SUN MOUNTAIN TOWNHOMES ZONE CHANGE AND DEVELOPMENT PLAN

PROJECT STATEMENT 2ND SUBMITTAL

Comments on Project Statement 2nd Submittal ---Kelly Hiller ----September 21, 2024

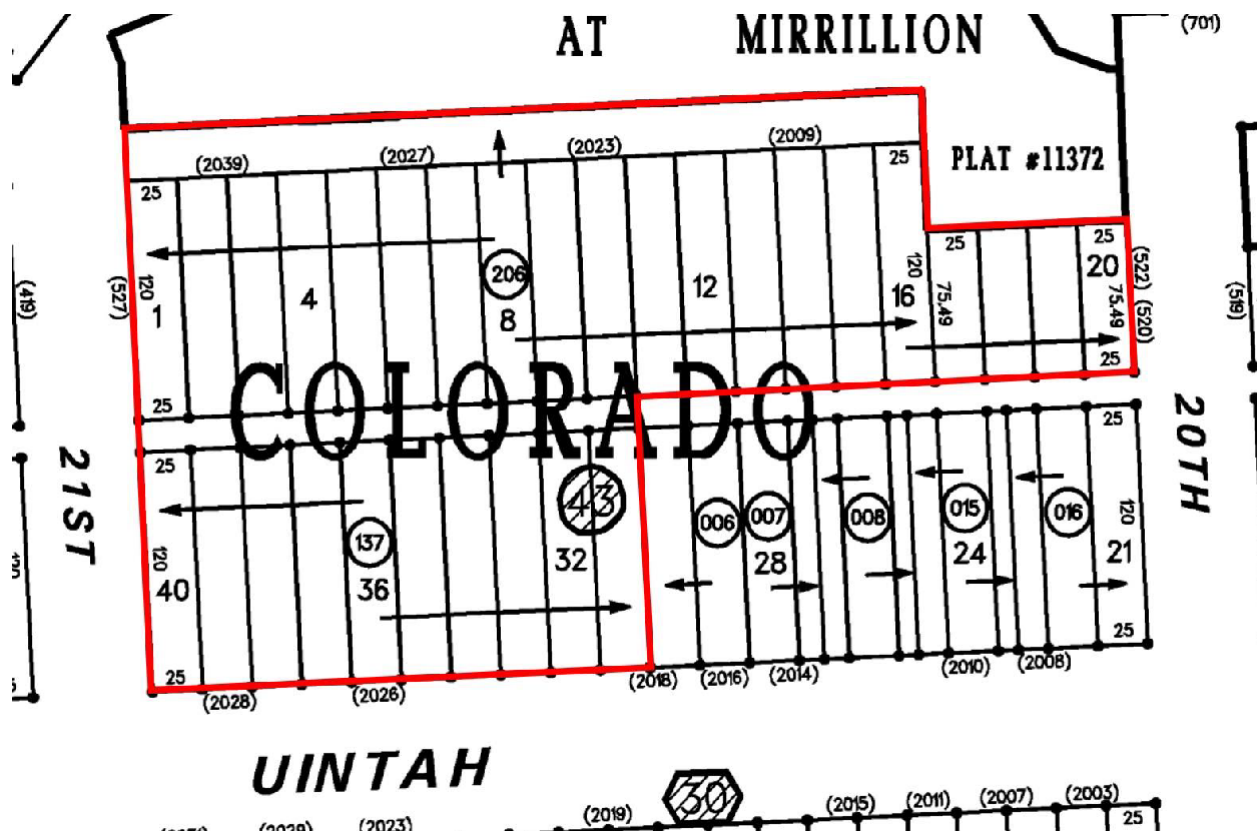
Surrounding Land Uses: The surrounding land uses includes ~~medium~~**LOW**-density residential townhomes to the north, single-family and high-density multi-family uses to the east across N 20th St, and multi-family and single-family uses to the south across W Uintah St. An analysis of surrounding densities **All adjacent parcels on the block are zoned R-2. Every adjacent property is zoned R-2 or in an existing low density PUD. The densities in the adjacent area range from 4.6 du/acre to 9.5 du/acre.**

Note: The Westside Plan has recommendations for this specific block that are relevant to the picture and information above. They cannot look east for comparable properties. From The Westside Plan in reference to this specific site: “any future land use changes should be subject to a review process that concentrates on compatible development as it relates to the less intense existing development to the north, west, and south.” – Westside Plan

The east was left out for a reason. The east had the more intense existing developments and The Westside Plan did not want them encroaching. Therefore, the east was not to be looked at when considering future developments. So, looking north, west, and south of the parcels at the time The Westside Plan was adopted by Ordinance 80-3, we see: vacant land to the north / R-2 to the west / R-2 to the south

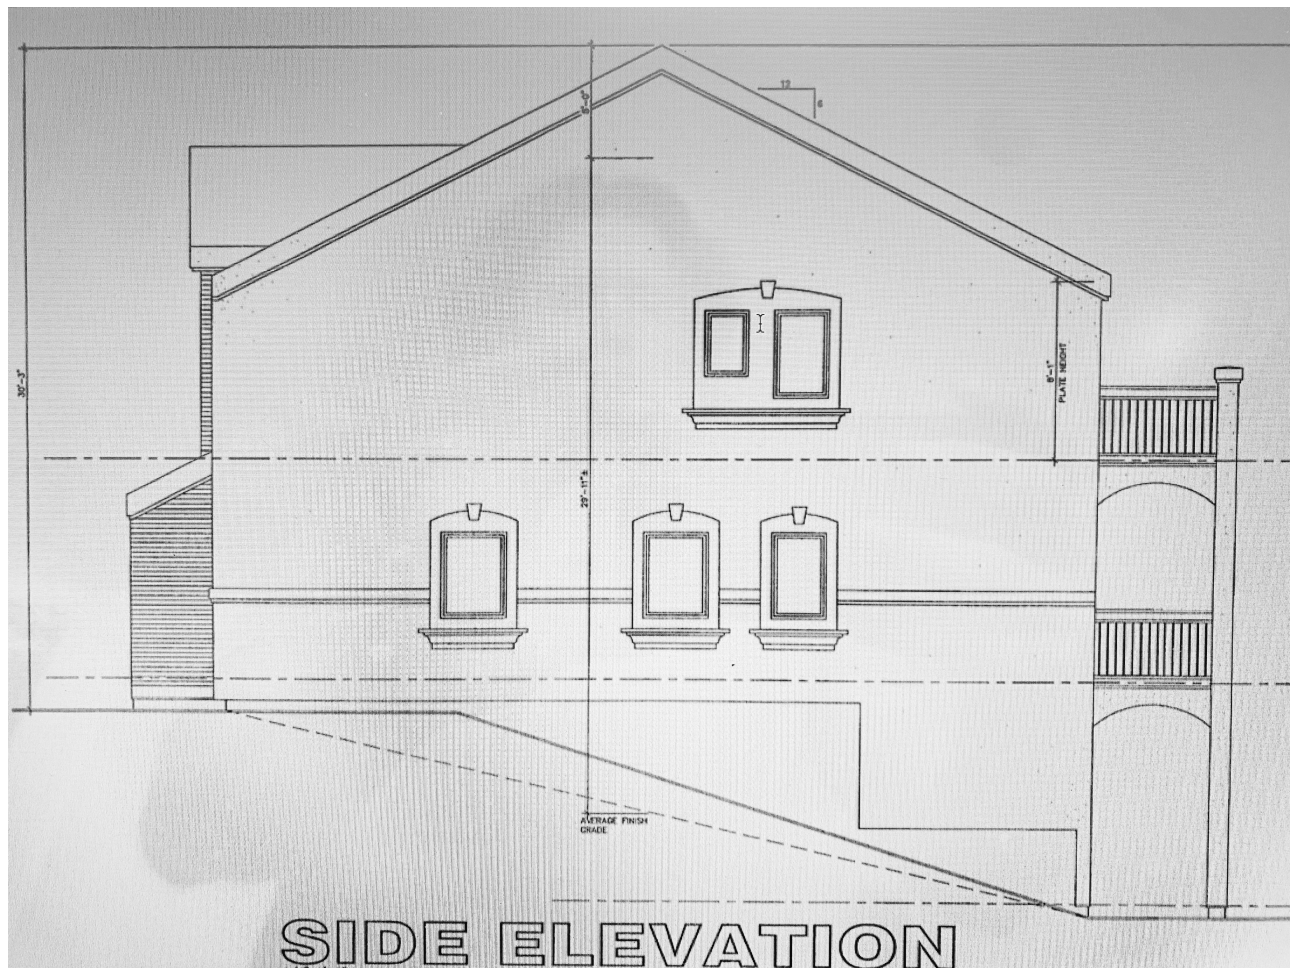
The city has accepted that the existing alley will remain an alley. Improvements to the alley will be required by the developer which will include paving the alley to meet city engineering standards which will improve drainage conditions and vehicular access. Double frontage lots will not be created with this project because the alley will not become a street. **If the applicant envisions using the alley as frontage for their lots, for a fire apparatus road, etc, they are creating double frontage lots. They are not allowed by code to use the alley as fire apparatus access nor front/primary access for their lots. So, the way to prevent double-frontage lots here is by not allowing them to go against the code to create them in an alley in the first place.**

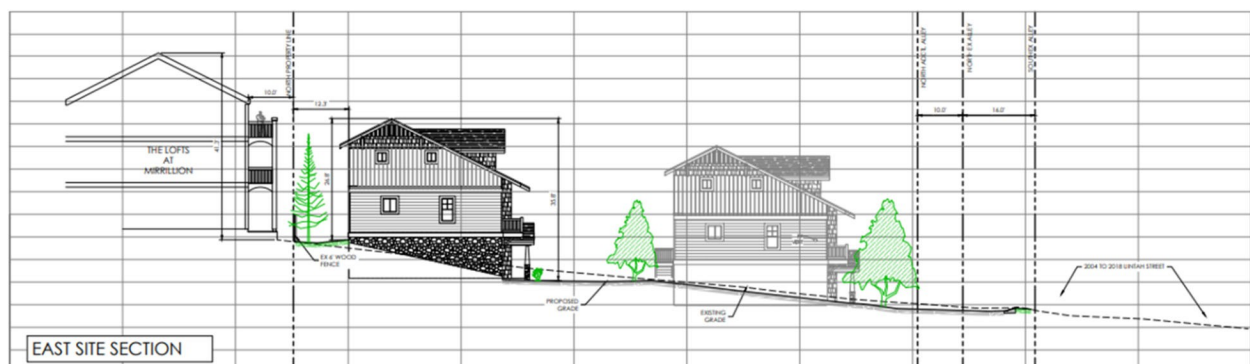
The below drawing DOES NOT accurately represent the building on the left (Mirrillion)

The proposed architectural style and materials are intended to match the character, bulk, and scale of the surrounding neighborhood. Building materials include stone, cement siding, and shingles. The maximum height of the structures is 32' with some variation in rooflines. At approximately 32' in height, the proposed townhomes are ~~shorter~~ **taller** than the existing townhomes north of the project which sit at the approximately ~~41' tall~~ **29.11' tall (see Mirrillion elevation below)**
